SUBJECT: FCC Class II Permissive change for FCC ID: **2ATUP-SM-2V0**

We, the undersigned, would like to request a Class II Permissive Change for the FCC ID: **2ATUP-SM-2V0**, which was originally granted on 04/24/2025.

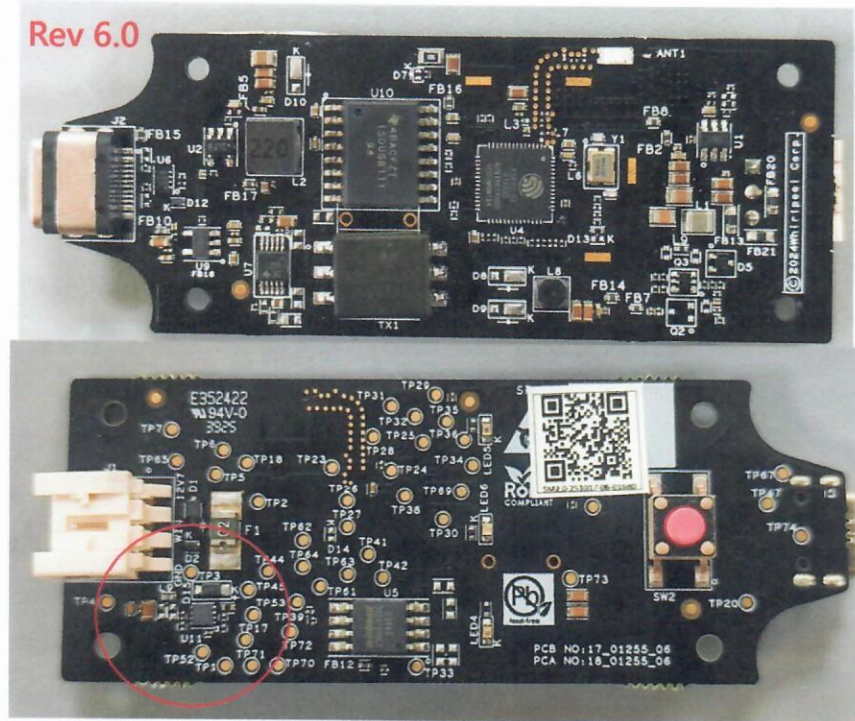
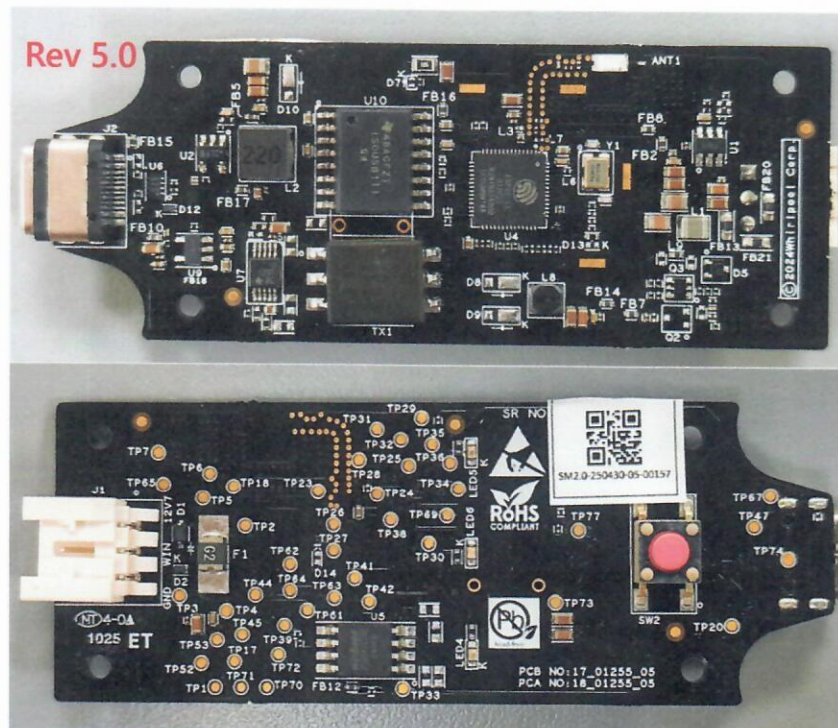
- 1.U11 and its required circuitry added for inrush control
- 2.R94,R96,R99 populated and R95,R97,R98 depopulated for the version control resistor.
3. R6 value updated from 84.5K to 86.6K
